Report: TAB REPORT
Function: Test, Adjust, & Balance
Date: 07/16/2025
Completed By: National TAB

PROJECT
07-14-25 CHIPOTLE #5446 CHARDON, OH

Project: 07-14-25 CHIPOTLE #5446 CHARDON, OH

RTU Ductwork Note

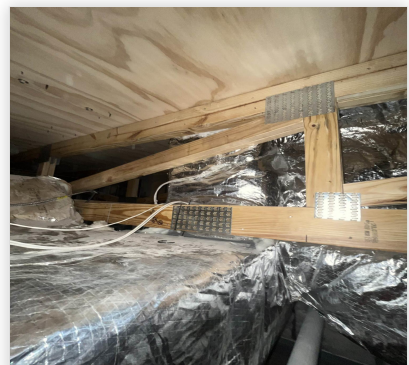
[1] RTU-2 SUPPLY AND RETURN DROPS DEVIATE FROM DESIGN DUE TO TRUSS INSTALLATION. SEVERAL TRANSITIONS AND TURNING VANES INSTALLED IN RETURN. SUPPLY AND RETURN ARE CRAMMED TOGETHER AT DROP. SEE PHOTOS

Asset: RTU2

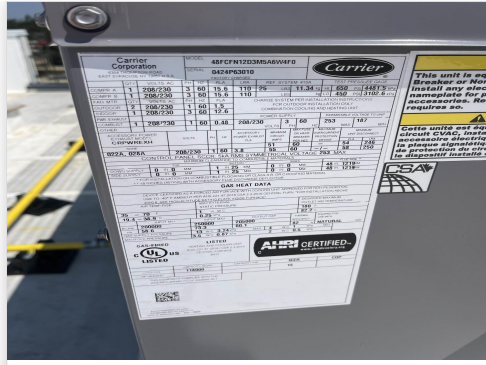
[1] DIFFUSERS SUM TO 4000 CFM. RTU SCHEDULE CALLS FOR 4400 CFM. PROPORTIONALLY INCREASED DIFFUSER VALUES TO MATCH RTU SCHEDULE. UNIT OPERATING AT 427 CFM/TON

[2] HIGHER THAN NORMAL NOISE FROM UNIT IN SPACE. SUSPECT INSTALLATION OF RTU DROP IS CAUSE, SEE ISSUE.
